SUBJECT: STORAGE OF CONSOLIDATED FUEL

Re: R. E. Ginna Nuclear Power Plant

Amendment No.12
License No. DPR-18

SAFETY EVALUATION BY THE OFFICE OF NUCLEAR REACTOR REGULATION
SUPPORTING AMENDMENT NO.12 TO FACILITY OPERATING LICENSE NO. DPR-18
ROCHESTER GAS AND ELECTRIC CORPORATION
R. E. GINNA NUCLEAR POWER PLANT
DOCKET NO. 50-244

FIGURE 5.4-1
SPENT FUEL STORAGE RACKS

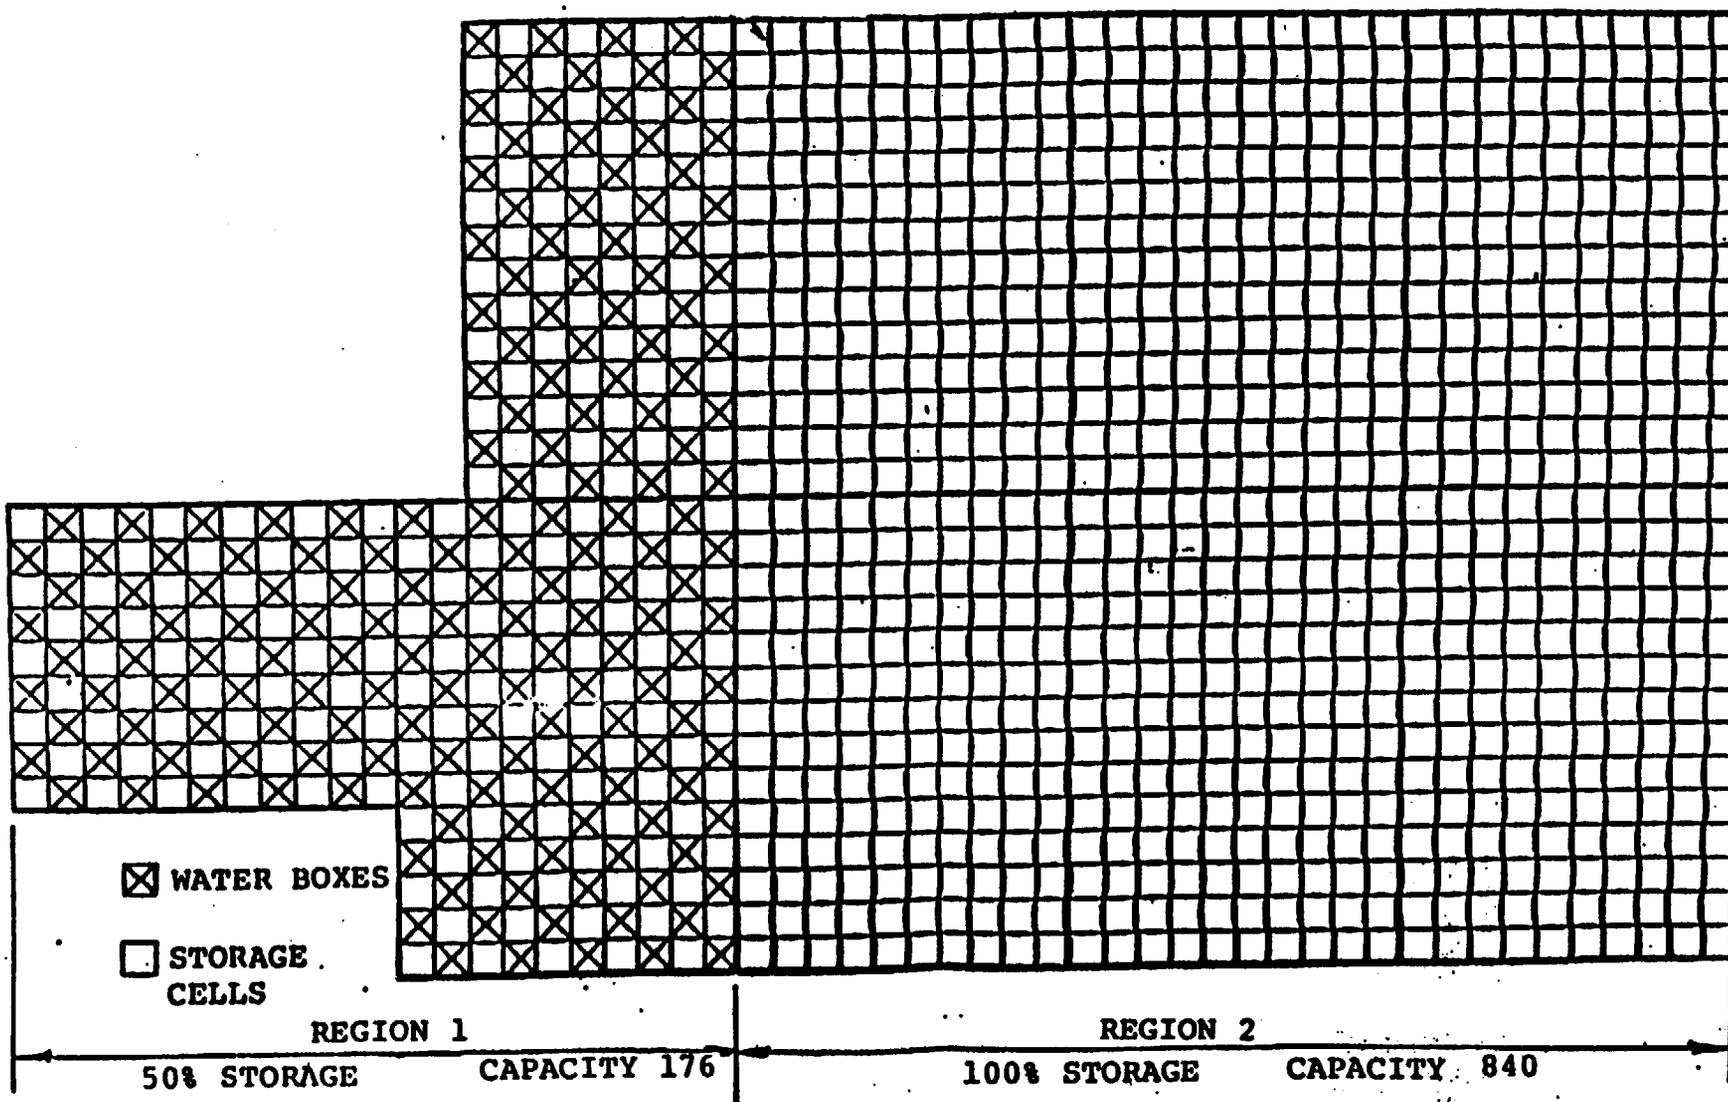
With the addition of the storage of consolidated fuel cannisters, the theoretical storage capacity of the pool would be increased to 2032 fuel assemblies (2x1016). However, due to limitation on the heat removal capability of the spent fuel pool cooling system, the storage capacity is limited to 1016 fuel assemblies.⁵

*TOTAL CAPACITY 1016 Fuel Assemblies

*Total Capacity includes provisions for storage of consolidated fuel.
